PLAN COMMISSION MEETING AGENDA

TUESDAY, May 26, 2015 AT 6:00 PM

MINUTES OF THE OAK CREEK PLAN COMMISSION MEETING TUESDAY, MAY 12, 2015

PRELIMINARY PLAT OF WILLOWSTONE

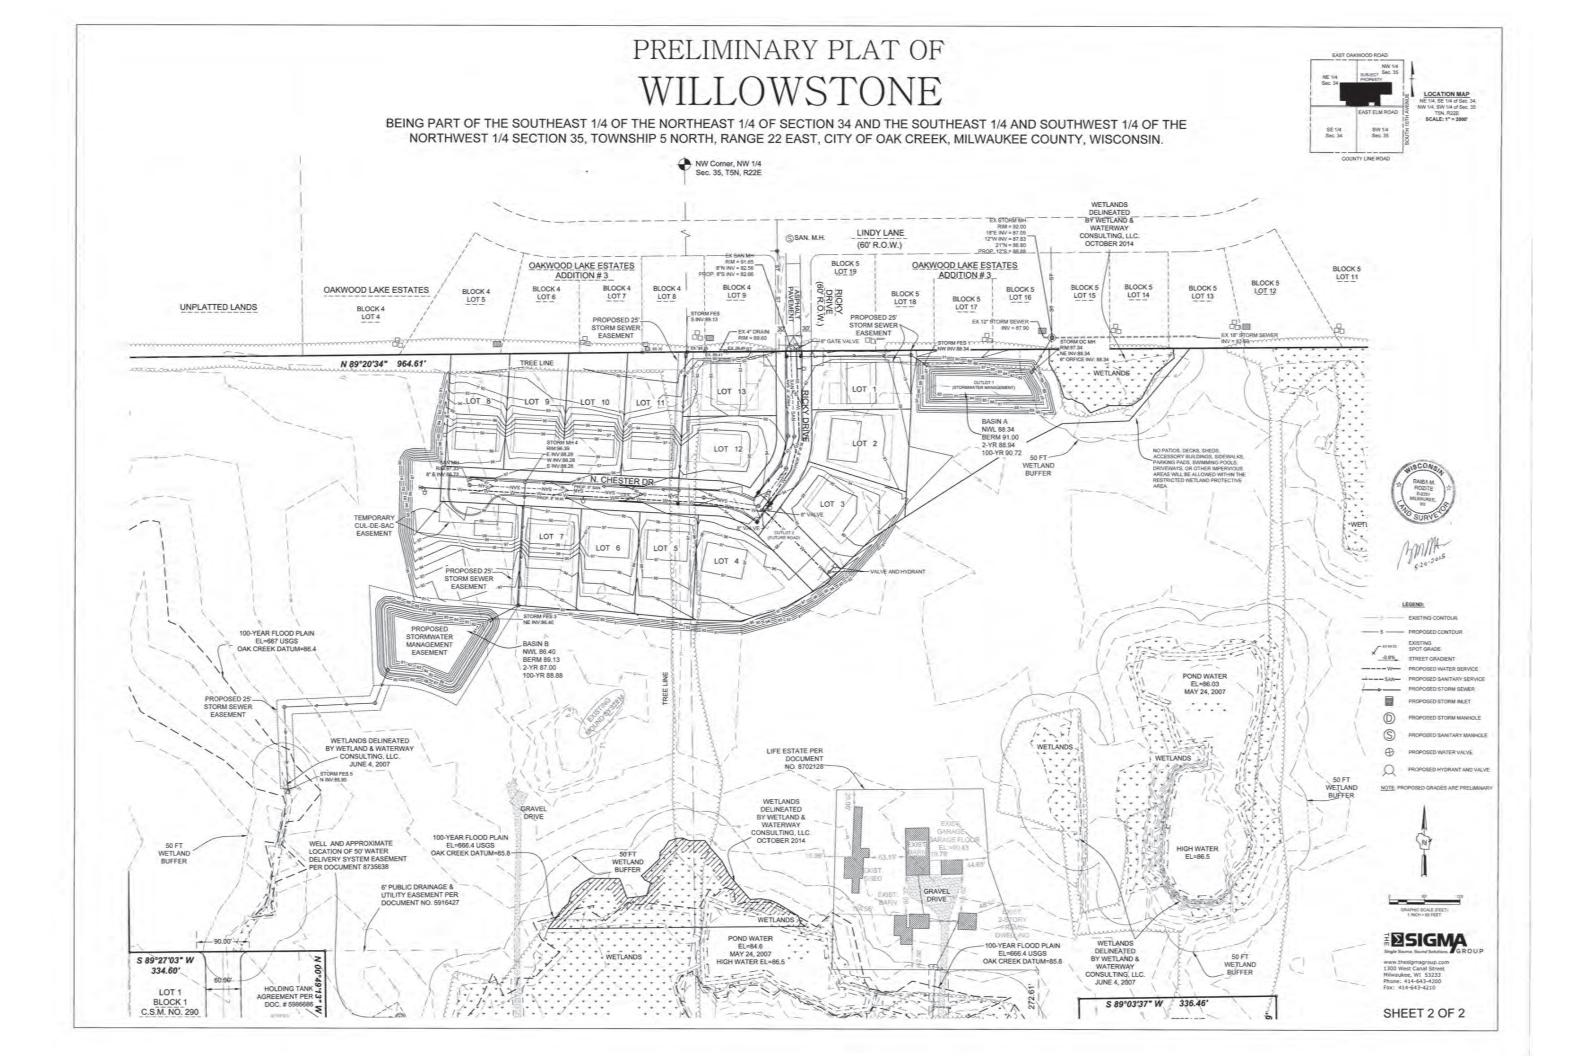
Staff notes that the proposed road – N. Chester Drive – has an incorrect direction (should be west), which must be revised on the final plat. Comments from the Water and Sewer Utility and Milwaukee County were received, and will be incorporated into the final subdivision plat.

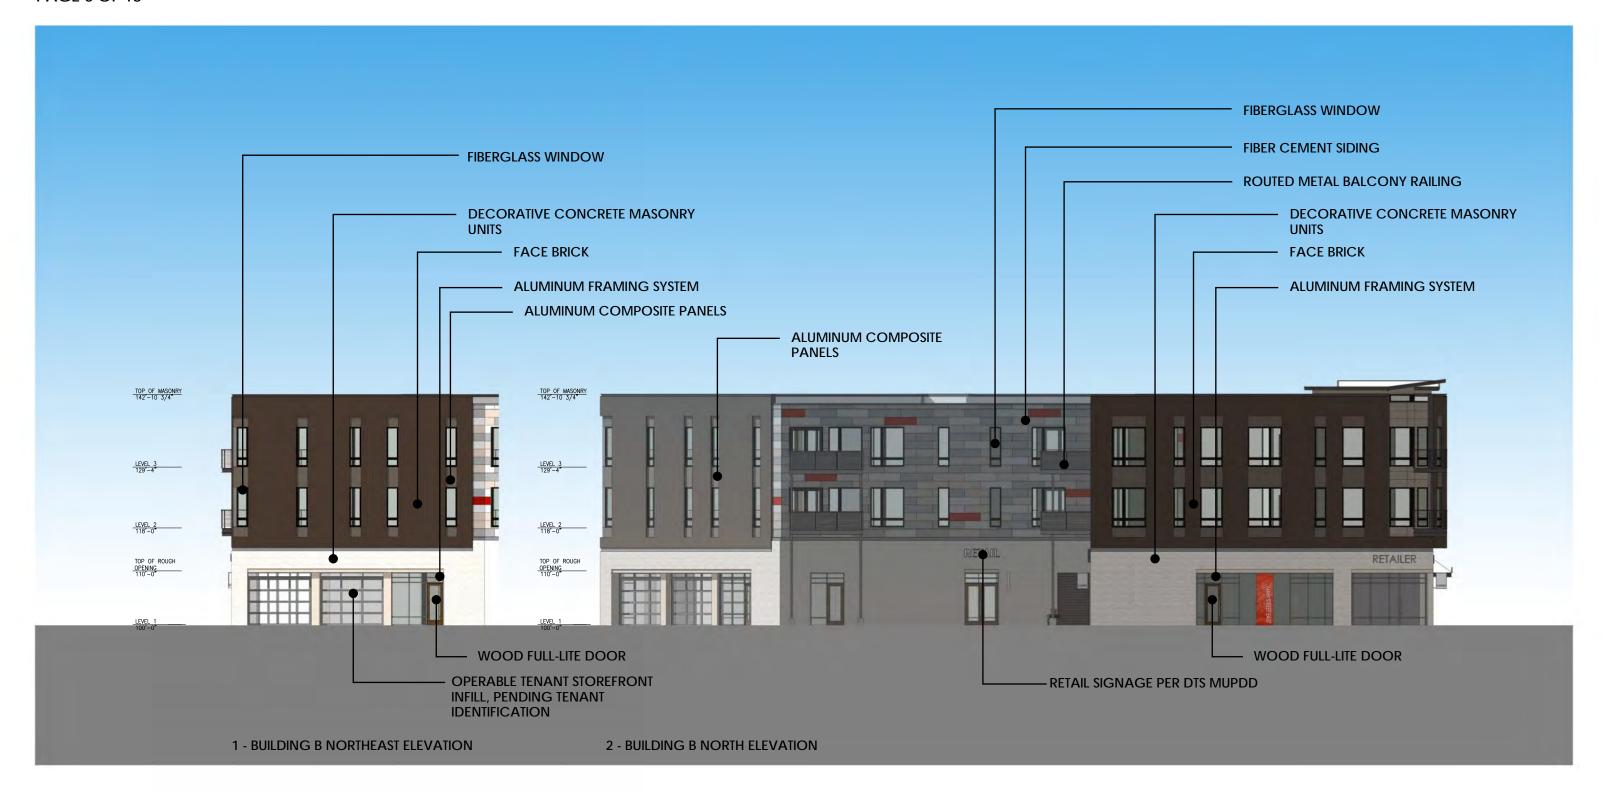
- The original balcony design at the back side of both buildings was simplified. A decorative screen proposed in the original design was eliminated.
- The fiber cement siding color and pattern was revised per the client's request. Building A originally included browns/wood tones with warm gray cement board. Building A is now comprised of multiple gray and white tones with yellow fiber cement accent panels primarily on the west elevation. Building B originally was a primarily brown and tan building. The east side now incorporates a multicolored fiber cement pattern in gray, gray/brown, and red tones.
- The phenolic wood panels, which accented windows and balconies, were replaced with aluminum composite panels.
